**Written submission from  
BWXT Nuclear Energy Canada Inc.  
in response to undertakings to  
provide clarification or additional  
information.**

**BWXT Nuclear Energy Canada Inc.,  
Toronto and Peterborough Facilities**

Application for the renewal of the licence for  
Toronto and Peterborough facilities

**Subject: Response to BWXT NEC undertakings from CNSC hearing March 2-6 with respect to FFOL-3620.01/2020**

**Figure 1 – Isopleth for a 1 g/s Fire in Building 7 (Toronto)**

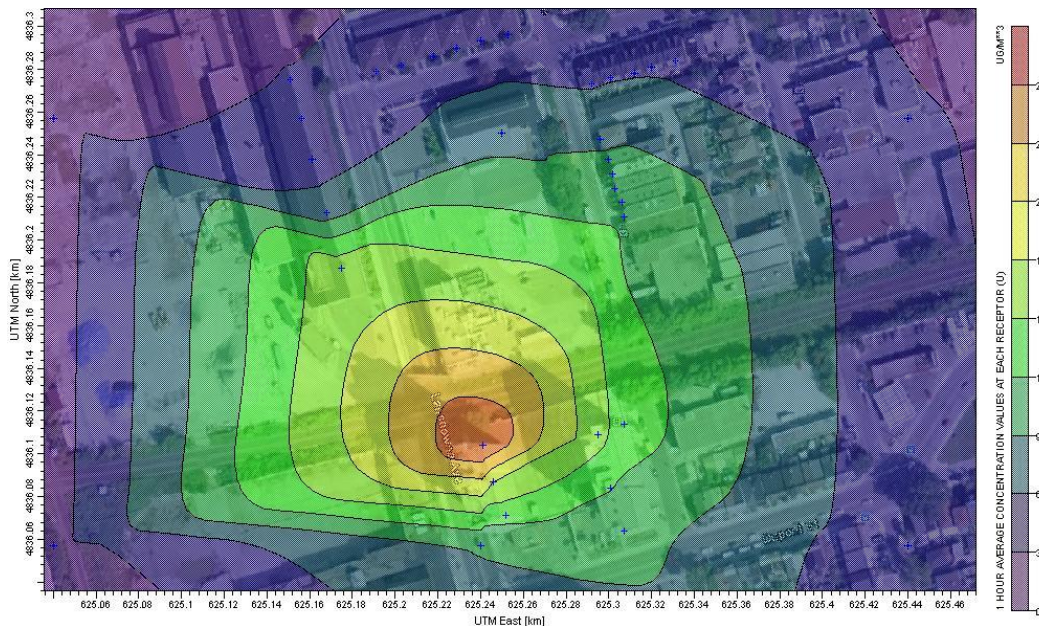
**2) Information with respect to the distance away from the Toronto facility that the maximum uranium in air concentration extends**

Isopleths of maximum one-hour concentrations were generated for each scenario based on a 1 g/s emission rate. Isopleths for the worst-case scenario are shown in Figure 1. These isopleths show the relative distribution of offsite concentrations around the facility and demonstrate how the concentration decreases away from the location of the maximum point of impingement.

The maximum concentration offsite extends 40 m beyond the fence and drops off beyond that point.

In preparing this memo, it was discovered that for Toronto scenarios, air dispersion dilution factors for Building 7 and Building 9 were transposed. This memo uses the corrected air dispersion dilution factors based on the isopleth in Figure 1. The Safety Analysis Report has been updated to reflect this correction which results in a reduction in the worst-case concentration from 6.1 mg/m<sup>3</sup> to 3.9 mg/m<sup>3</sup>.
